# NOvA Safety Advice

I would like advice on fire protection issues, on environmental issues (including byproducts from a fire or from fighting a fire), on the requirements for decommissioning , on “pressure vessels”, ....(on whatever else am I missing).... for the proposed NOvA experiment. NOvA would be located in far far northern Minnesota, 810 km from Fermilab, just south of Voyageur’s National Park on the Canadian border.

**What would we have to do to build this device at Fermilab?**

### BC-517L Oil

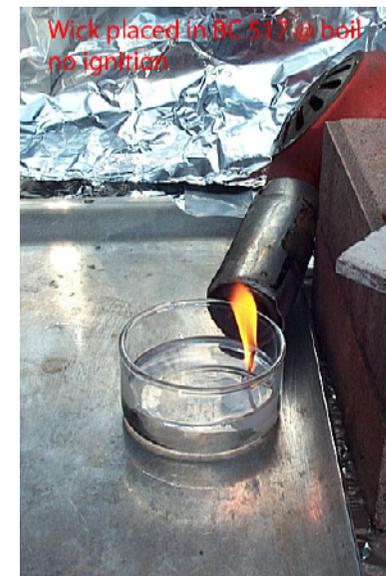
It is a combustible mixture rather than a flammable mixture. >140 F

1. Exposed to low energy flame for 10 seconds. No ignition
2. Exposed to low energy flame for 30 seconds. No ignition
3. Exposed to candle wick burning at surface of BC-517. No ignition but increased flame on wick.

Low energy flame 30 seconds added to the candle flame. No ignition.

## Fire Testing Oil:

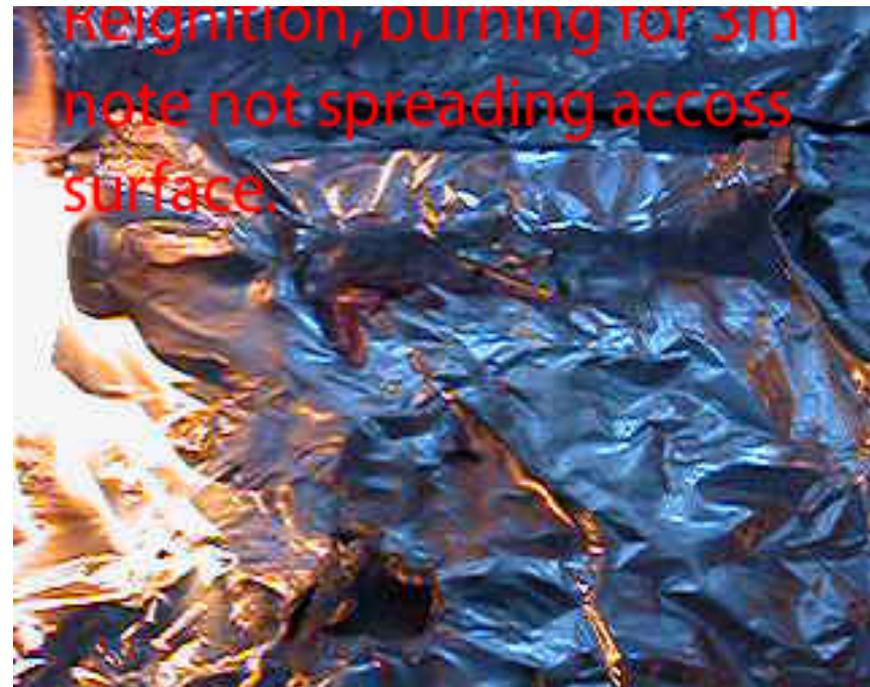
A torch was applied to the pool (BC-517L) which was at 150 F. Ignition occurred and stayed continued to burn till manually extinguished after three minutes. The interesting observation was the burning after three minutes did not migrate across the rough surface of the pan.
